Attachment H

**Effects of changing height of Cape's Dam on recreation, Texas wild
rice and fountain darter habitat in the San Marcos River, Texas**

**Watershed Systems Group, INC
San Marcos, Texas**

June 24, 2015

Figure 2. Example of field measured topography points (A) and computational mesh mapped onto elevation contours (B) and substrate (C).

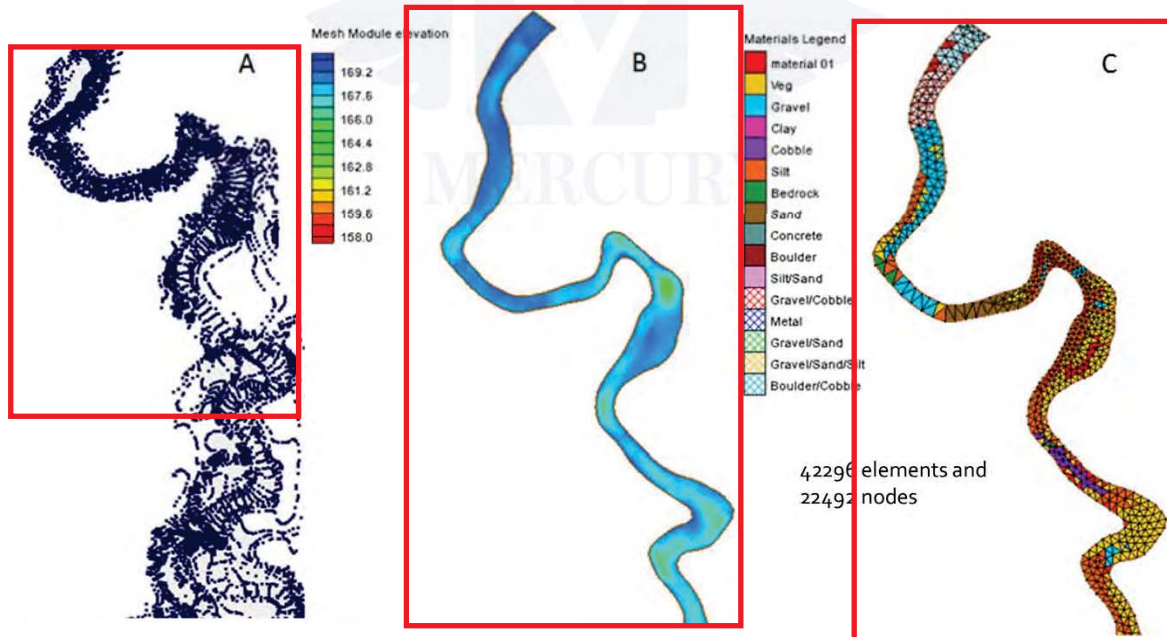
These 3 depictions of Figure 2 do not cover the same aerial extent and are thus invalid comparisons.

Figure 4. Assumed computation mesh for full height Capes Dam used in the hydrodynamic modeling.

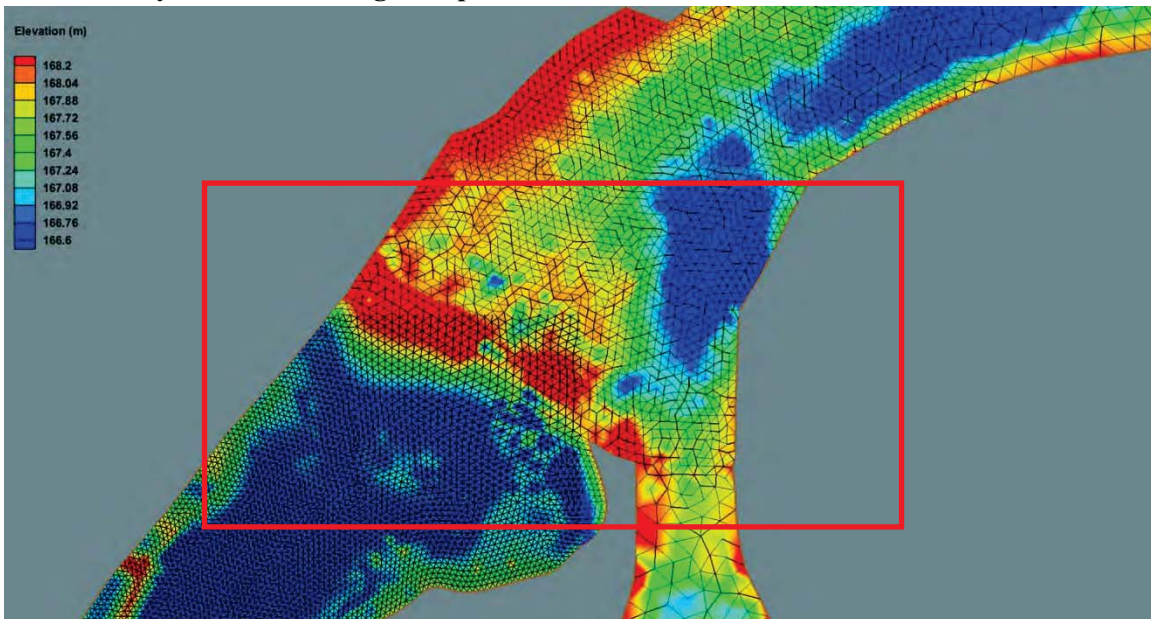
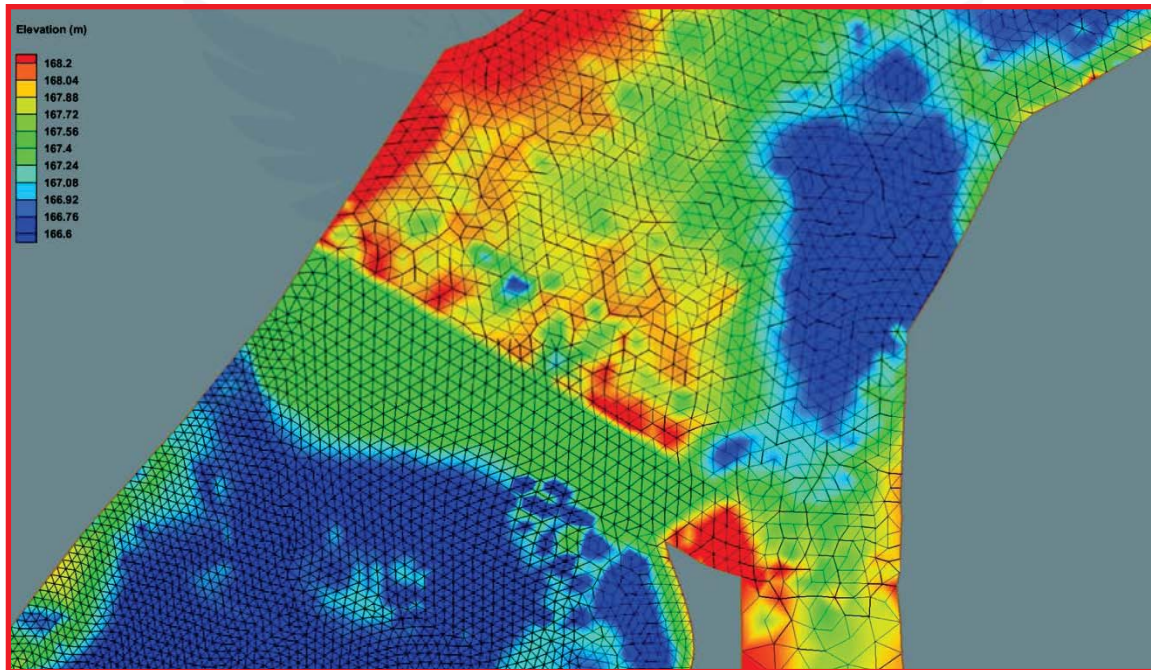
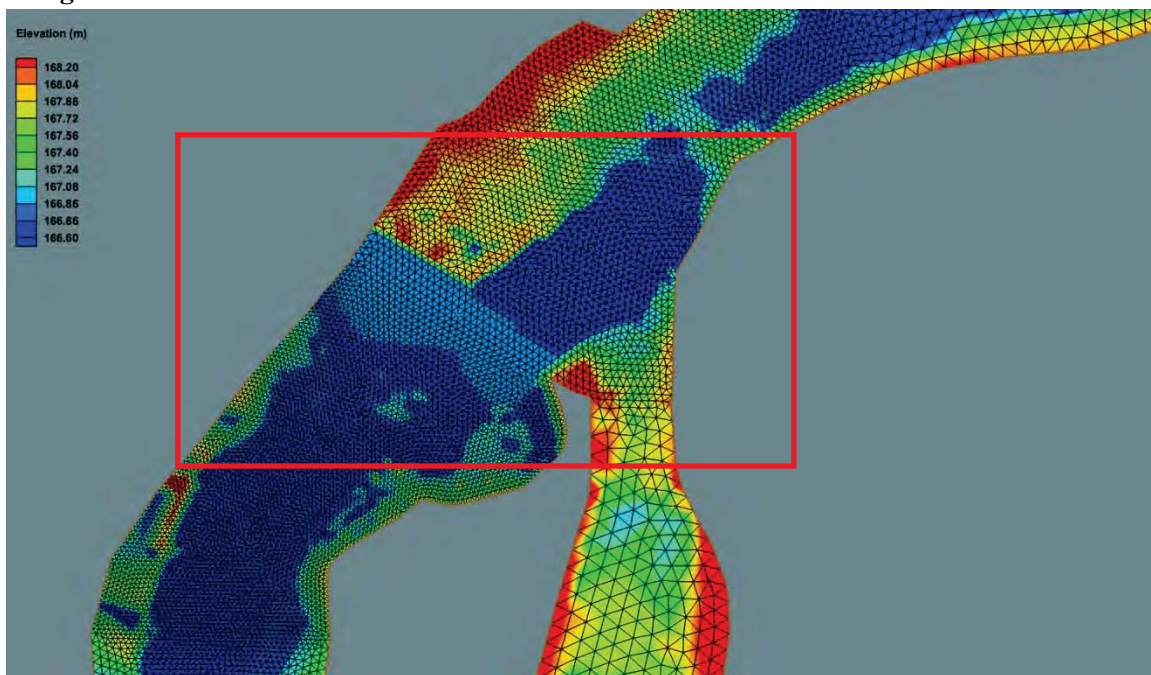
Red box indicates approximate outline of area shown in Figures 5 and 6. According to basic science protocols, when making a comparison, the scale of the diagram and the aerial extent of the 3 comparisons should be identical; Figures 4 through 6 show different areas, at different scales, rendering the purported comparison between Fig 4 thru 6 meaningless.

Figures 4 through 6 purport to show the effects of changing Capes Dam's heights, and yet the scale and area of the San Marcos River is different in each of the 3 diagrams. This is *not* only not science, this is highly unethical slanting of the visual display by tricking the reader into thinking they are looking at observable changes that are only the effect of changing the scale and aerial extent of the photo.

Figure 10. Computed bed shear stress at 300 cfs for each of the dam scenarios.

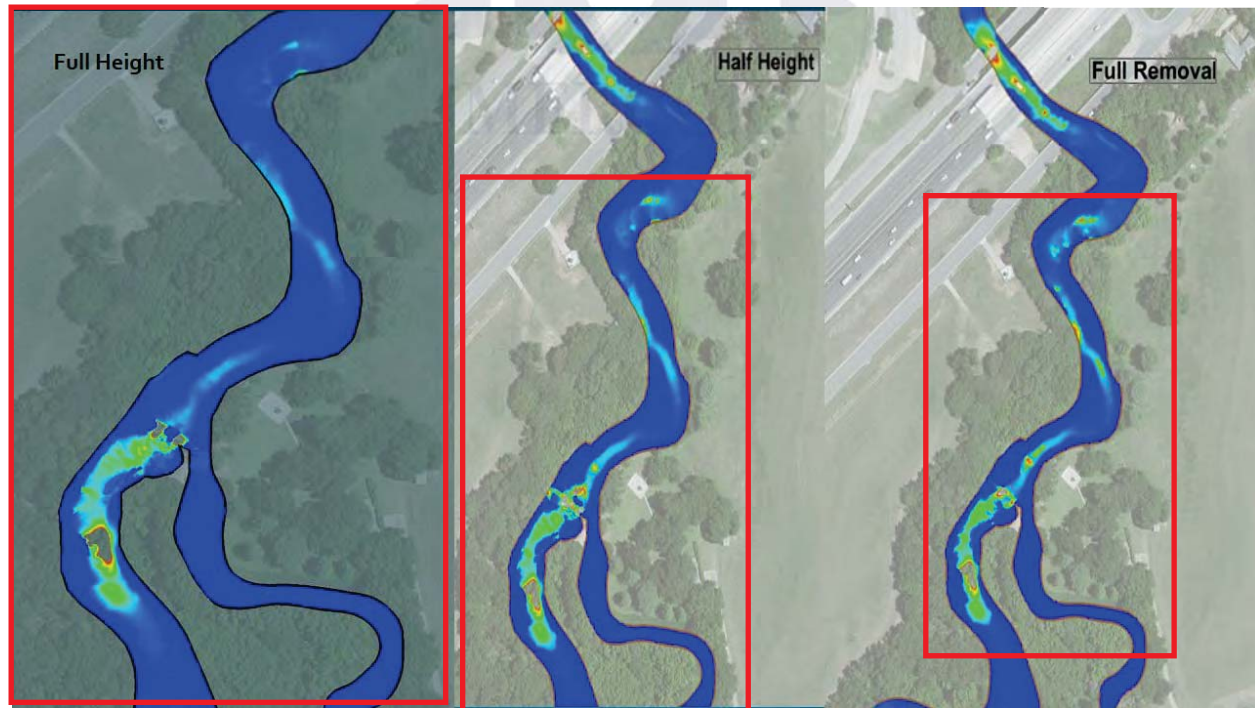
What Figure 10 actually displays is of questionable scientific value since the areal extent depicted has both diminished and been reduced in scale, as Capes Dam height has been simulated reduced, down to being completely removed in the right-most image. This reduction in aerial extent, while slightly skewing the image, demonstrates nothing.

Figure 11. Velocity magnitude and directions at 300 cfs under full height, half height and full dam removal.

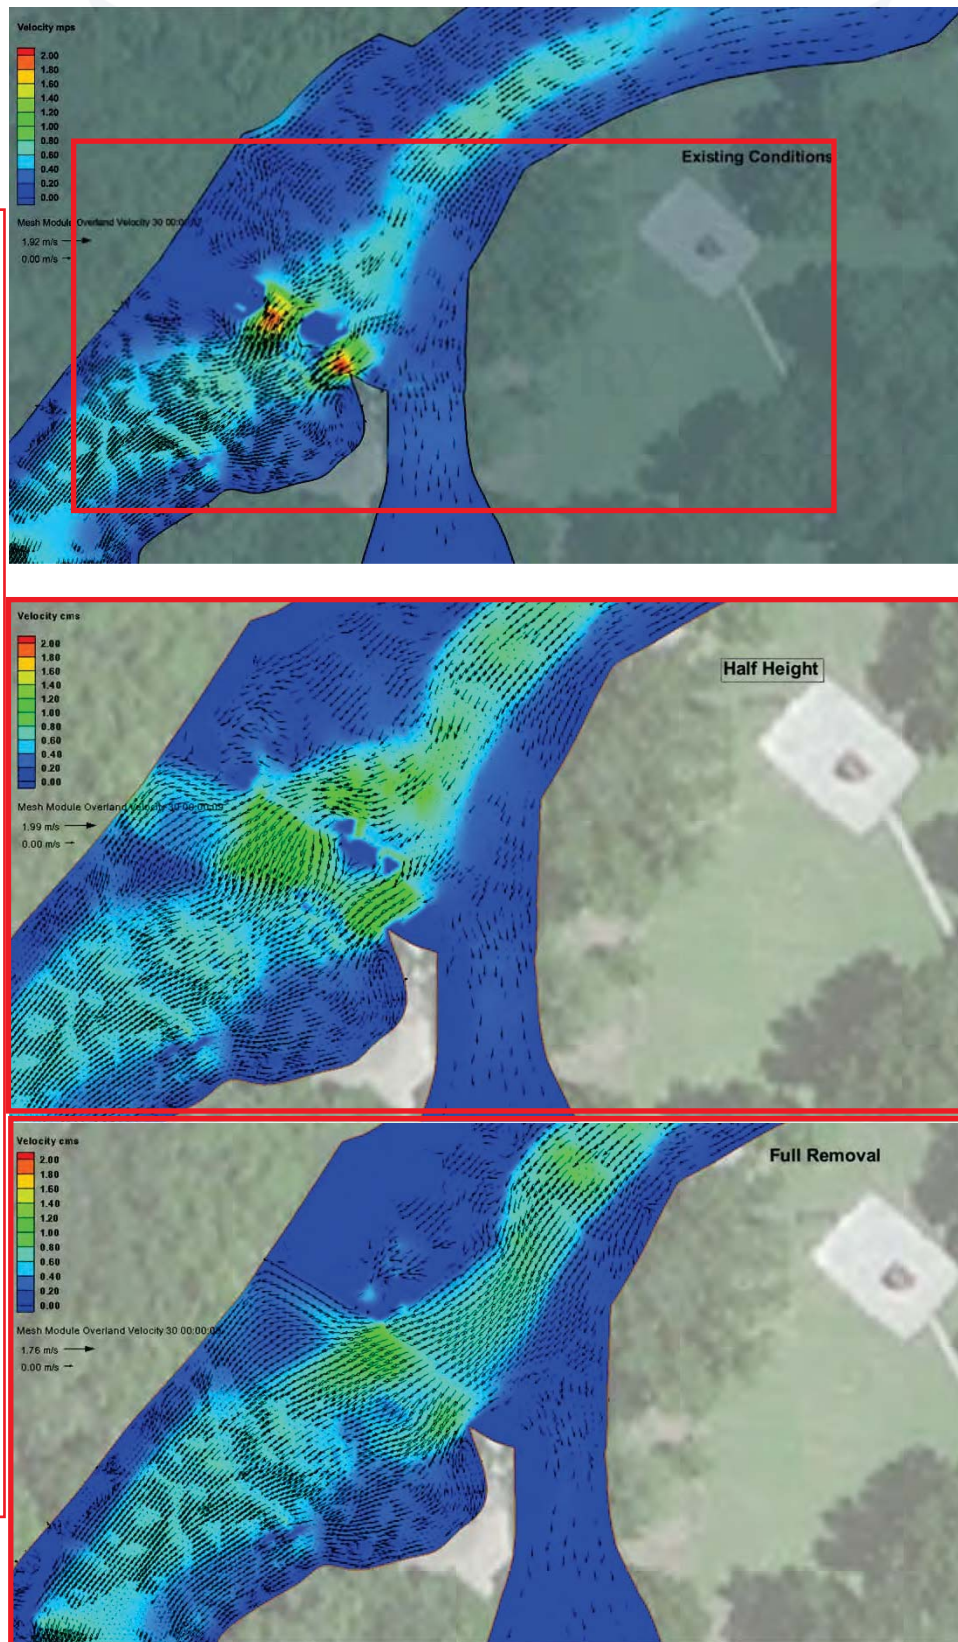
In Figure 11, what are "Existing Conditions" of Capes Dam? There has been considerable erosion since the Memorial Day 2013 Flood, and further modifications in subsequent record-breaking floods of Memorial Day 2015 and Halloween 2015. Why are "Existing Conditions" displayed at a different scale than "half-height" and "Full Removal"? Why is the location of Capes Dam never identified in this comparison of proposed removal of Capes Dam?

Figure 12. Mobility of fine sediments at 300 cfs under full, half height, and full removal of Capes Dam.

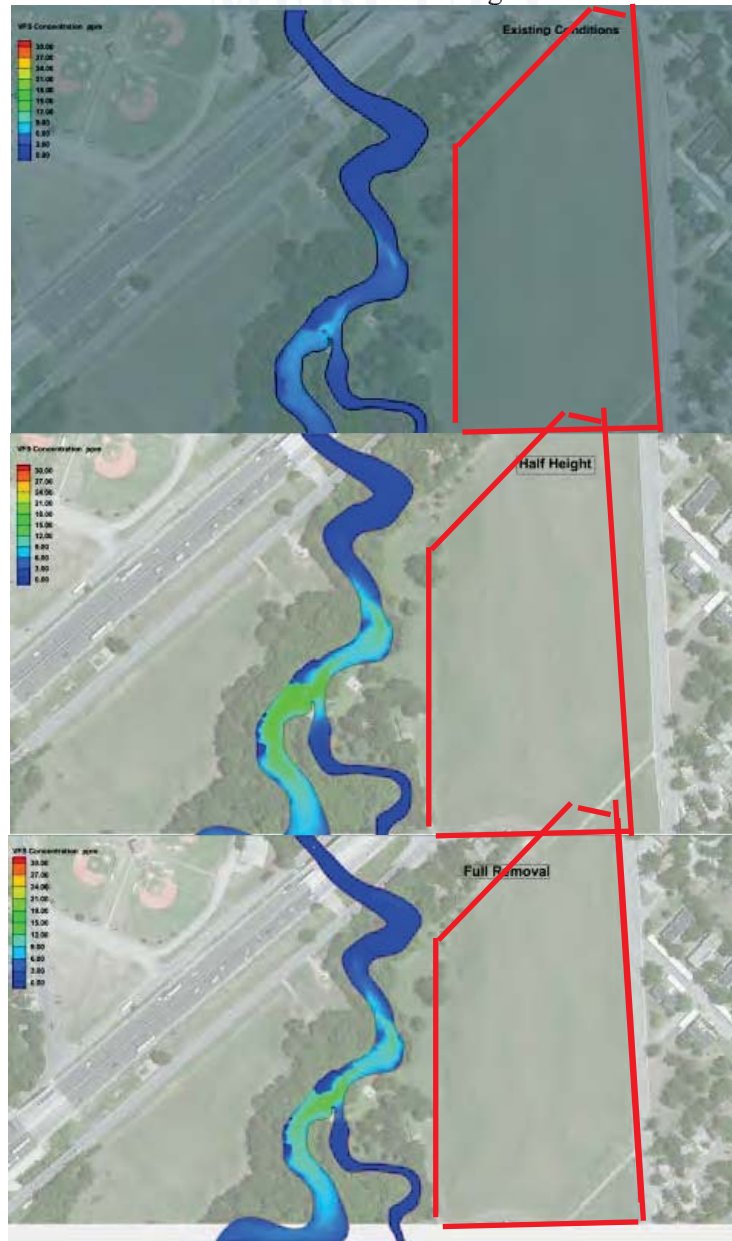
In Figure 12, why is the Woods Apt Complex, occupying 24 acres (outlined in red) and having over 450,000 sq ft of improvements, worth \$44 Million on Hays County Tax Rolls, omitted from this figure, which uses out-dated aerial imagery?

Why is the scale changed between the 3 images? The change of scale is demonstrated by the red outline of what should be the Woods Apt Complex not fitting into each image without reduction/enlargement?

Figure 13. Area of normalized available habitat as a percent of the stream area for Texas wild for different flow rates and dam scenarios.

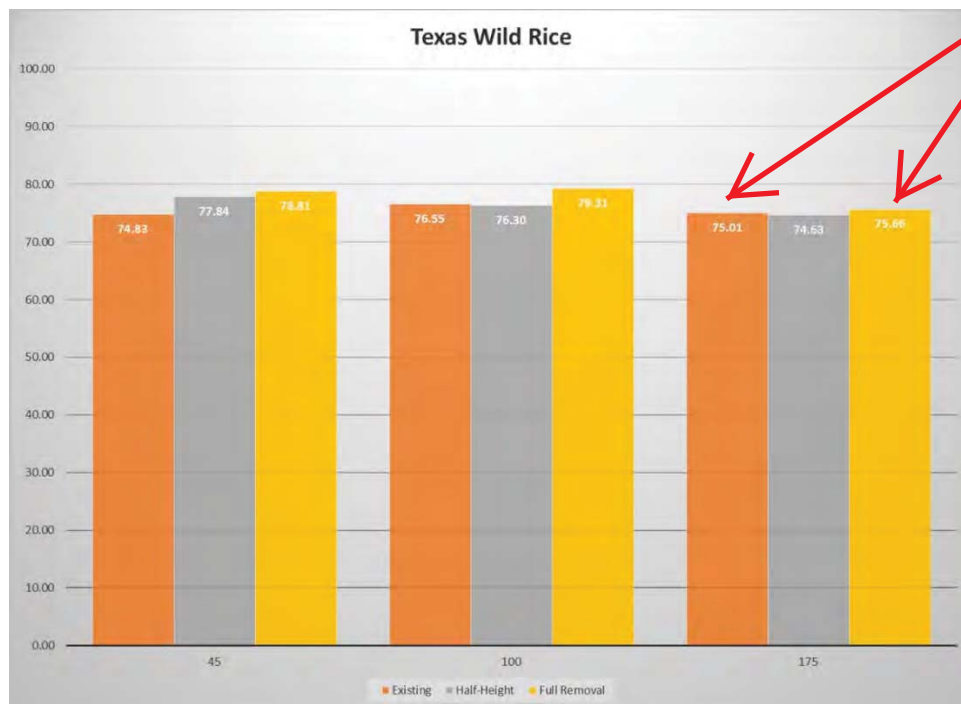
This graph shows only a 0.6% increase in favorable habitat for TWR at flow rates averaged to 175 CFS.

Furthermore this graph omits the "above-average flow rate" of 300 CFS Hardy which uses in Figs 8, 10 & 11 of this report. In other words, Figs 8, 10 & 11 of this report are based on a nearly double CFS than Hardy's prediction of a 0.6% increase in favorable habitat for TWR.

The difference between 175 CFS and 300 CFS is 80 Million Gallons/Day.

Figure 14. Area of normalized available habitat as a percent of the stream area for fountain darter for different flow rates and dam scenarios.

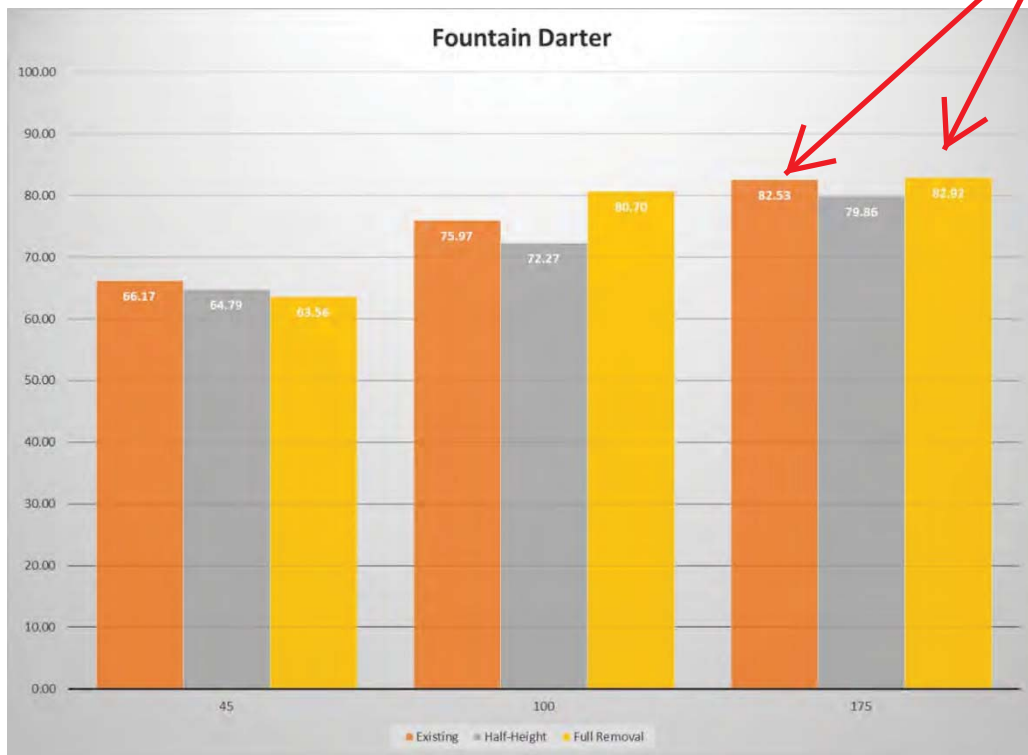
This graph shows only a 0.4% increase in favorable habitat for Fountain Darter at flow rates averaged to 175 CFS.

Furthermore this graph omits the "above-average flow rate" of 300 CFS Hardy which uses in Figs 8, 10 & 11 of this report. In other words, Figs 8, 10 & 11 of this report are based on a nearly double CFS than Hardy's prediction of a 0.4% increase in favorable habitat for the Fountain Darter.

The difference between 175 CFS and 300 CFS is 80 Million Gallons/Day.

Dr Hardy admits in his Conclusions that "**incremental reductions in fountain darter habitat are suggested by these modeling results**" while Fig 14 on page 16 show a 0.6% increase in Fountain Darter habitat -- which conclusion is correct? Dr Hardy's work - not just on the San Marcos River but through-out his research history - is rife with this type of contradictory statements of hypotheses as fact.
